United States Patent and Trademark Office

APPLICATION NO.	FILING DATE	FIRST NAMED INVENTOR	ATTORNEY DOCKET NO.	CONFIRMATION NO.
09/692,123	10/20/2000	Paul R. Lesch JR.	8066-057	6851
28765 75	590 03/01/2004		EXAMINER	
WINSTON & STRAWN			THOMPSON, KATHRYN L	
PATENT DEPARTMENT 1400 L STREET, N.W.			ART UNIT	PAPER NUMBER
WASHINGTON, DC 20005-3502			3763	; (
		•	DATE MAILED: 03/01/2004	24

DETAILED ACTION

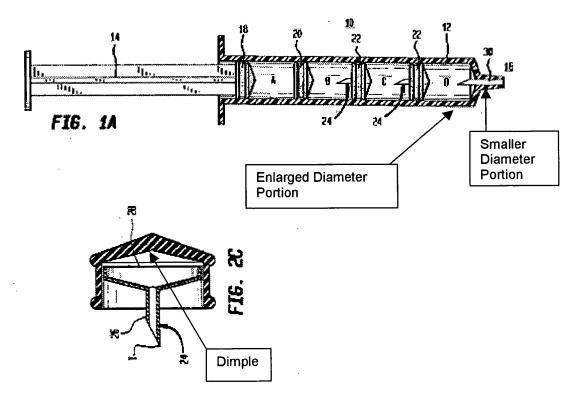
Claims 1, 2, 3, 6, 7, 9-13,16, and 29 are rejected under 35 U.S.C. 102(b) as being anticipated by Richmond (US 5,102, 388). Richmond discloses a jet injector comprising a medicament cartridge comprising a medicament, a tube, a needle having a piercing end with a bevel extending into the lumen, a first stopper within and against the lumen, a second stopper within and against the lumen, wherein movement of the first stopper with respect to the tube causes the piercing end of the needle to pierce the first stopper and movement of the second stopper with respect to the tube compresses the medicament held between the second stopper and the first stopper so that the medicament is expelled through the fluid pathway, wherein the lumen has a portion with an enlarged diameter (See Figure 1A Below) and further comprising a third stopper within the lumen located between the second stopper and the enlarged diameter, wherein the first stopper has a frustroconical shape, wherein the second stopper has a medicament contacting surface configured and dimensioned to mate with the frustroconical shape of the first stopper (Figure 2D), wherein the first stopper has a

dimple and narrow cross-section where the needle penetrates the first stopper (See Figure 2C Below), wherein the cartridge is configured for use in combination with an injection device (14) for firing the cartridge to expel the medicament.
